ACCESSION NBR: 7907130250 .DOC. DATE: 79/07/06 NOTARIZED: NO DOCKET #
 FACIL: 50-244 Robert Emmet Ginna Nuclear Plant, Unit 1, Rochester G 05000244
 AUTH. NAME AUTHOR AFFILIATION
 WHITE, L. D. Rochester Gas & Electric Corp.
 RECIP. NAME RECIPIENT AFFILIATION
 ZIEMANN, D. L. Operating Reactors Branch 2

SUBJECT: Forwards addl info re pressure shielding steel diaphragm,
 in response to questions raised during review of 790517
 submittal.

Subject: Pressure Shielding Steel Diaphragm
R.E. Ginna Nuclear Power Plant
Docket No. 50-244

R.E. Ginna - Figure 1
Turbine Building Pressurization - 24" Main Steam
Calculated Differential Pressure vs Time
Mezzanine Level - Environment
Initial Conditions: $T_0 = 120^\circ\text{F}$
 $RH = 0\%$

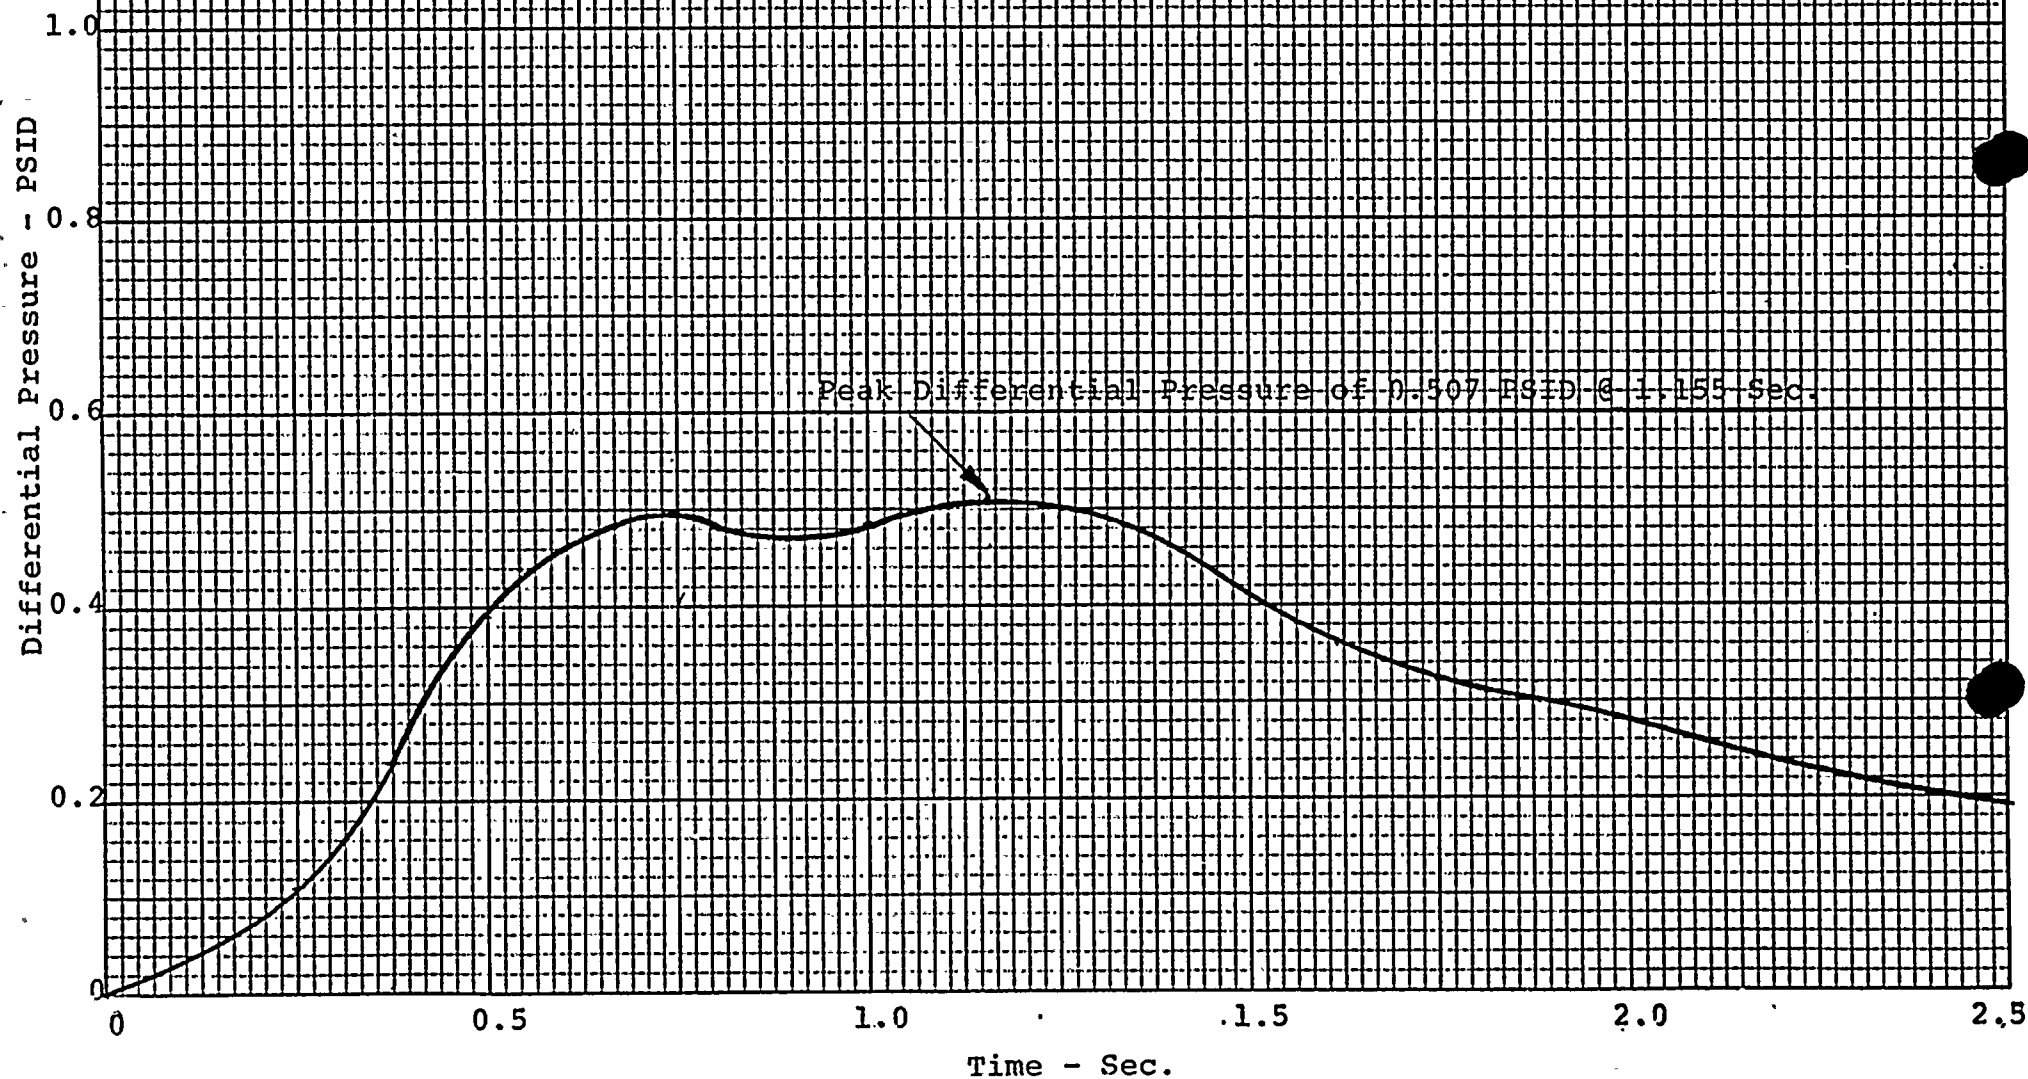
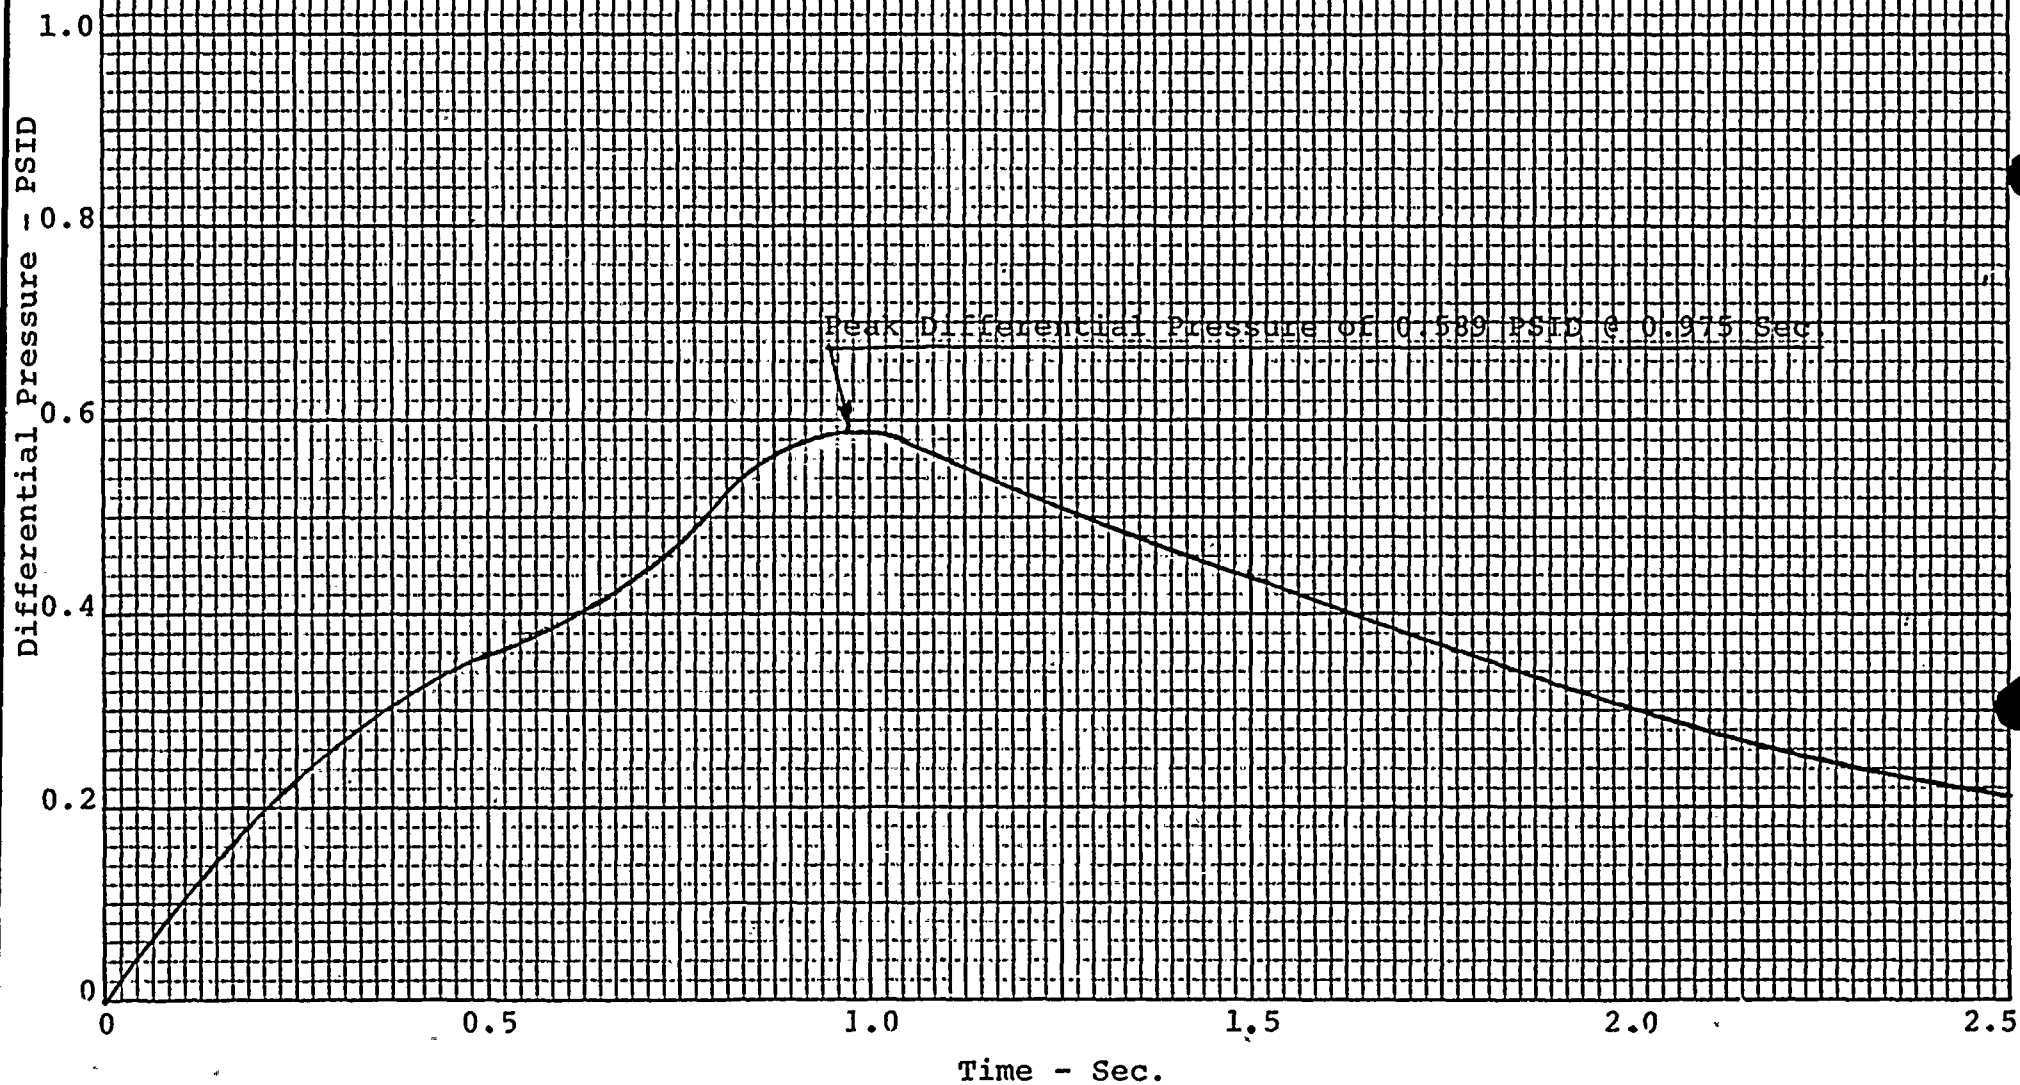
Members of your Staff requested that we investigate the consequences of an instantaneous double-ended guillotine break in either the 24" or the 36" main steam lines in the turbine building. This request was made recognizing that such breaks are precluded by the augmented inservice inspection program which has previously

been reviewed and approved by the NRC Staff. Nonetheless, the two breaks have been analyzed. The peak pressures on the mezzanine and operating levels from a 24" steam line break on the operating level are 0.507 psid and 0.589 psid respectively. The results for the 36" main steam line break on the mezzanine level for the mezzanine and operating levels are 1.264 psid and 0.742 psid, respectively. Curves of pressure vs. time for these two breaks are provided in Enclosure II to this letter. In the calculation of the pressure transient following a 24" steam line break, credit was taken for failure of a section of block wall as described and justified in our letter of May 17, 1979. In the calculation of the pressure transient resulting from a 36" steam line break, credit was taken for failure of the block wall and for failure of the building exterior siding. The exterior siding will fail at a pressure of 0.93 psi. This failure pressure is based on consideration of the siding design and method of attachment to the building and is set as the ultimate capacity of the aluminum panels in tension. A total of 2166 ft² on the mezzanine/basement elevations is assumed to fail. Since the pressure on the operating level for the 36" steam line break does not reach 0.93 psi, the siding at that elevation is assumed to remain in place.
